MEMORANDUM
Comfort Lake-Forest Lake Watershed District

Subject: Permit 22-030 Bottem Landscaping Parking Lot

Project	Bottem Landscaping Site Improvements	Date	10-19-2022
To	Mike Kinney	Contact Info	CLFLWD
Cc	Board of Managers	Contact Info	CLFLWD
From	Greg D. Graske, P.E.	Contact Info	EOR
Regarding	Permit Application #22-030, City of Wyoming

GRADING AND EROSION CONTROL PLAN

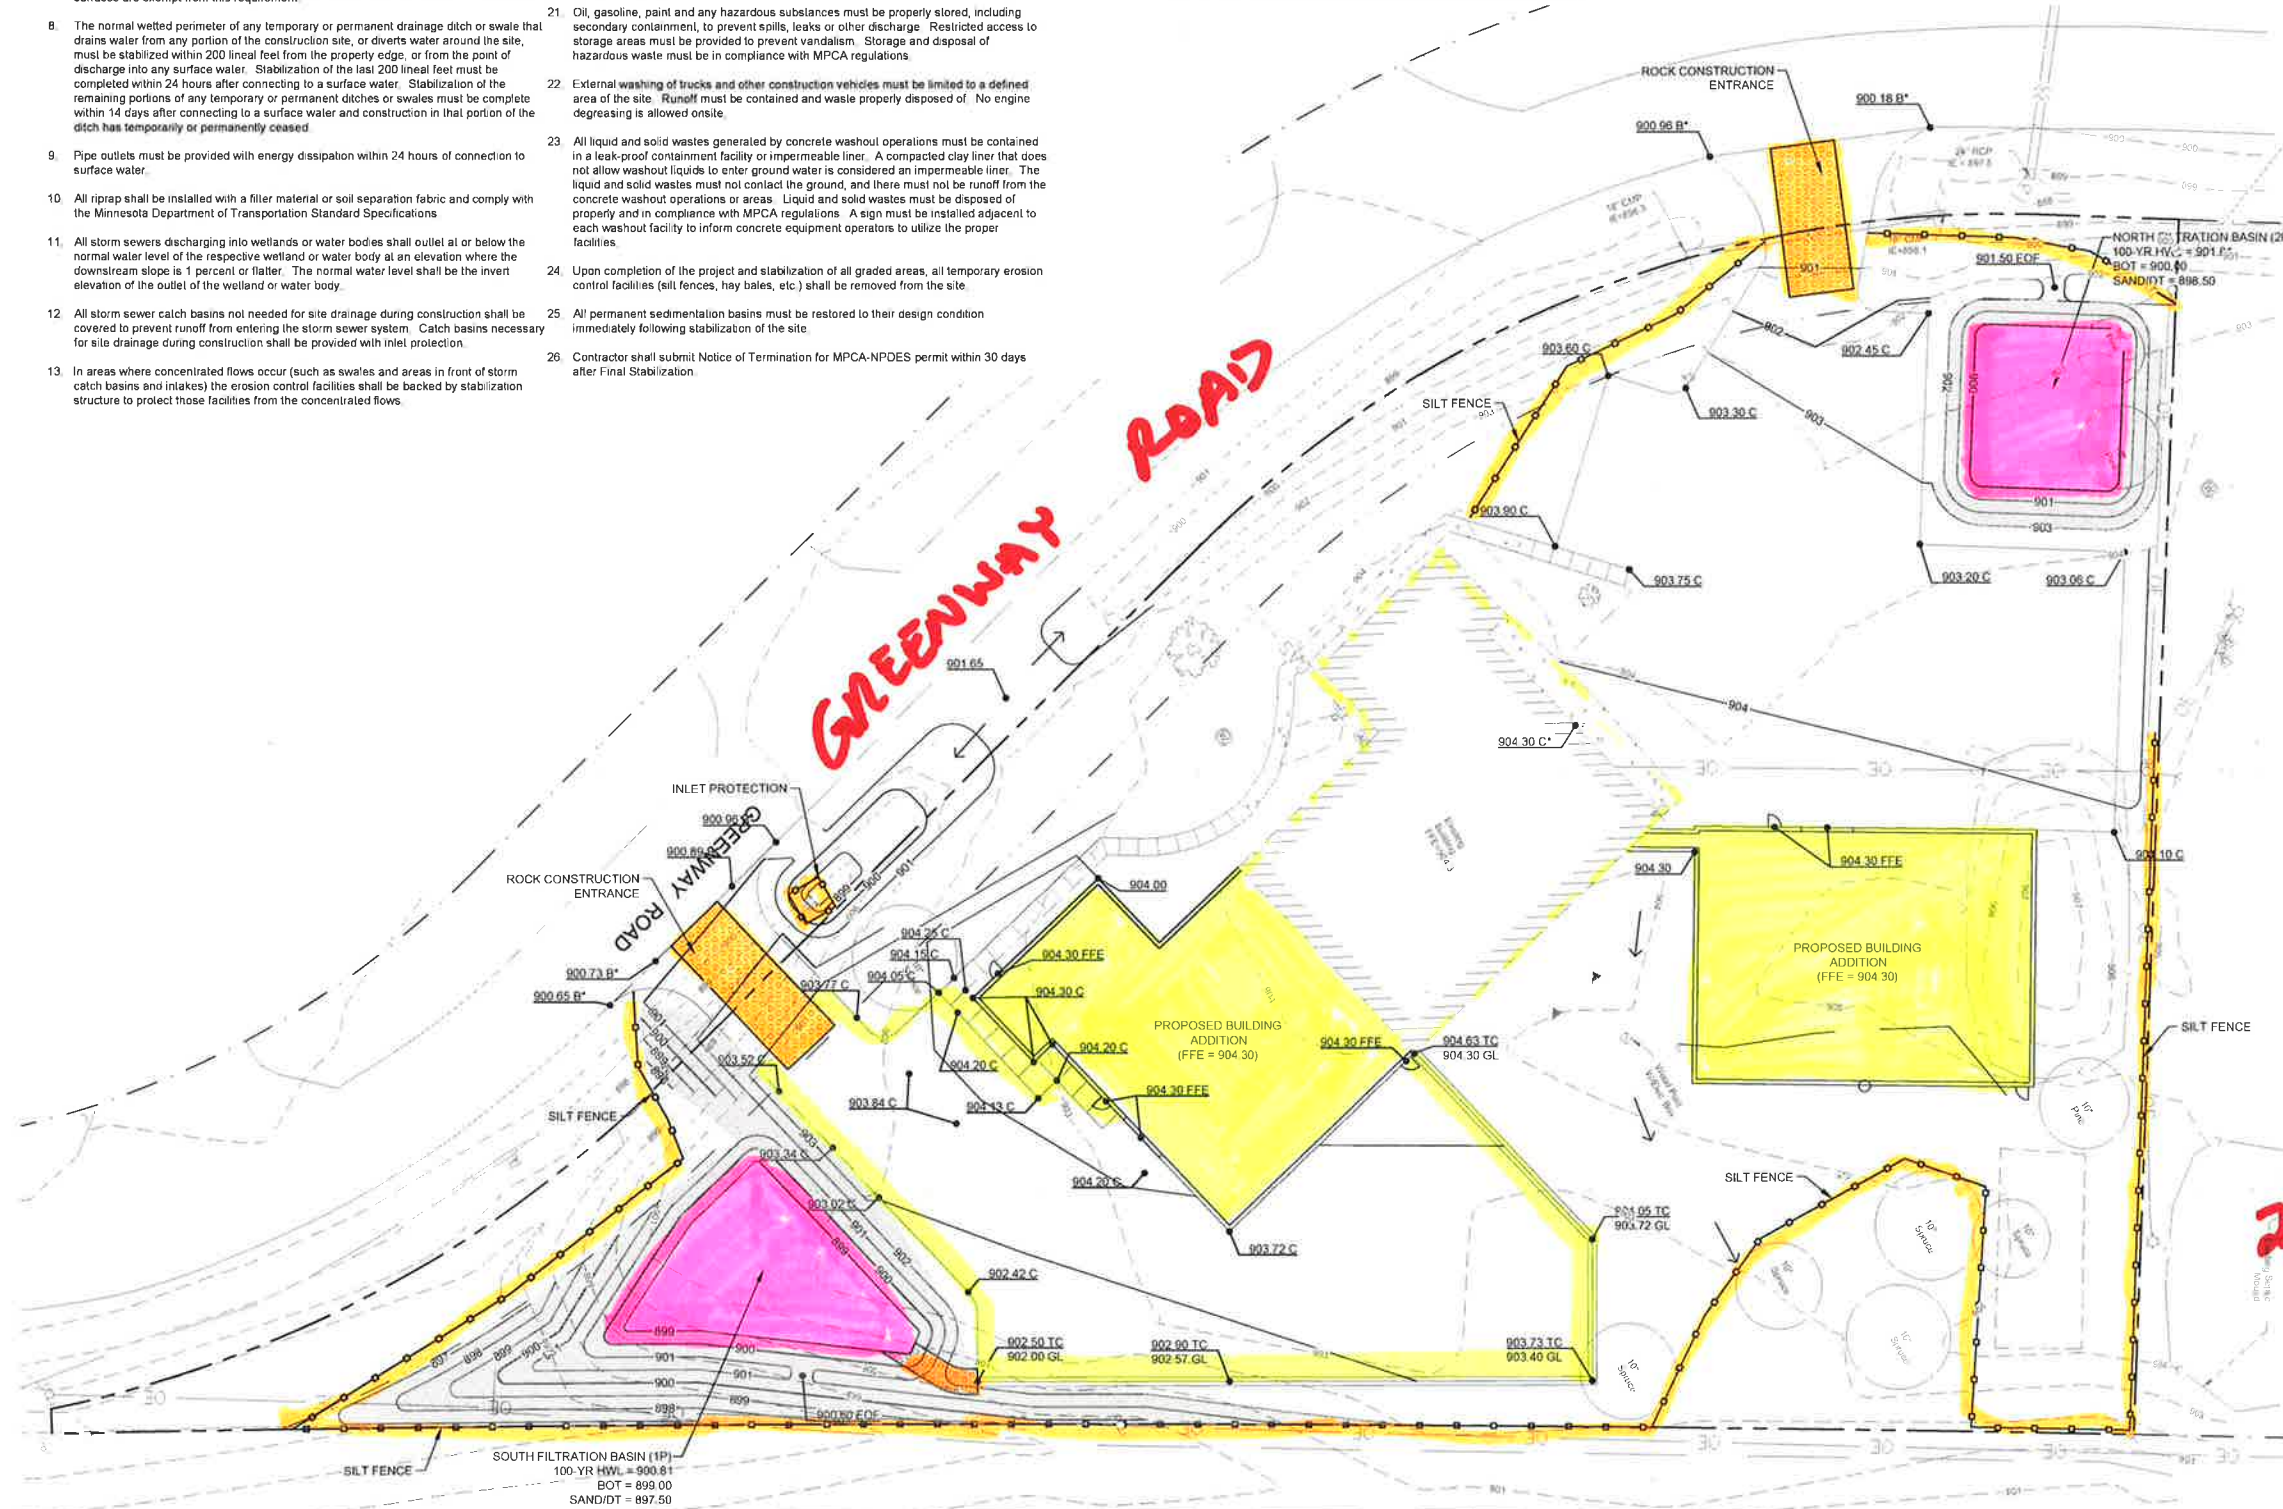
The project will consist of the construction of two new building additions, parking lot expansion, and associated stormwater facilities and utilities. The impervious area runoff will be routed to two large biofiltration basins. Pretreatment will be provided by directing runoff over grass filter strips prior to

For redevelopment projects, the required treatment volume of 1.1 inches of runoff from all new and reconstructed impervious surfaces must be captured and treated. Since the project is disturbing more than 50% of the site the existing impervious areas must be treated also. Infiltration is not feasible due to clay soil types. The proposed biofiltration basins requires use of the 0.65 conversion factor for treatment volume. This results in a total required treatment volume of 37,662 CF. The combination of the two underground treatment facilities provides 37,743 CF of treatment volume, therefore meeting the District volume requirements. The majority of the site impervious will be routed to the proposed treatment basins. Some minor areas on the perimeter and portions of the rooftops will sheet flow through green space where suspended solids will be removed from this runoff to the maximum extent practicable.

Construction details for the proposed biofiltration basins has been provided. The soil mix will consist of an 80-10-10 mix of sand-compost-peat to minimize the potential of phosphorous leaching. Construction sequencing notes have been provided indicated that the proposed BMPs will be built concurrently with the work authorized under this permit.

Discharge from the site reduces peak rates compared to existing conditions at all discharge locations, thereby satisfying District Rate Control requirements. A summary table of rates leaving the site is below.

The existing and proposed building low floor elevations meet District freeboard requirements over the proposed biofiltration basins.

The proposed project includes silt fence downstream of graded areas, inlet protection at all catch basins, and two rock construction entrances, revegetation specification, and an implementation schedule. A detailed Storm Water Pollution Prevention Plan (SWPPP) has also been provided.

Recommendation: Approval, with issuance on receipt of the following:

1. Additional permit review deposit of \$250.
2. Execution of a maintenance instrument satisfactory to the CLFLWD addressing the ongoing operation and maintenance of the proposed stormwater management features. The proposed instrument shall be provided to the District for review prior to execution, and documentation of recording with the County must be provided before permit issuance.
3. Financial Assurance in the amount of \$2,600 for grading and alteration.
4. Financial Assurance in the amount of \$13,000 for stormwater management or demonstration that the applicant has provided the municipality with a financial assurance, specific to the stormwater facilities, of equal or greater value.
